Corridor 229-254(S)

Mullan to Alberton Corridor

Figure 3. Map of Conflict Areas in Vicinity of Corridor 229-254(S)

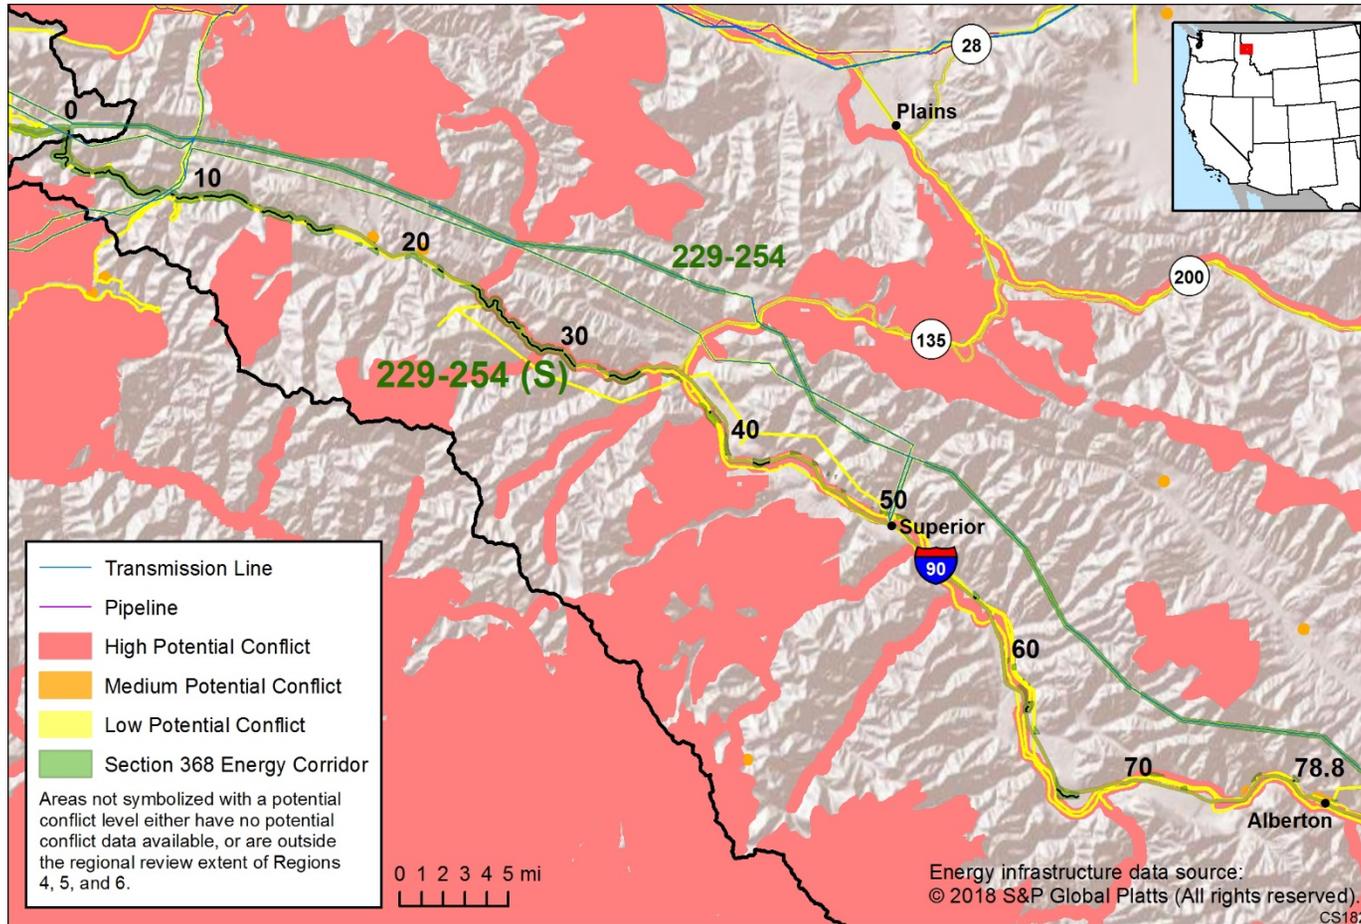
Figure 3 reflects a comprehensive resource conflict assessment developed to enable the Agencies and stakeholders to visualize a corridor’s proximity to environmentally sensitive areas and to evaluate options for routes with lower potential conflict. The potential conflict assessment (low, medium, high) shown in the figure is based on [criteria](#) found on the WVEC Information Center at www.corridoreis.anl.gov. To meet the intent of the Energy Policy Act and the Settlement Agreement siting principles, corridors may be located in areas where there is potentially high resource conflict; however, where feasible, opportunity for corridor revisions should be identified in areas with potentially lower conflict.
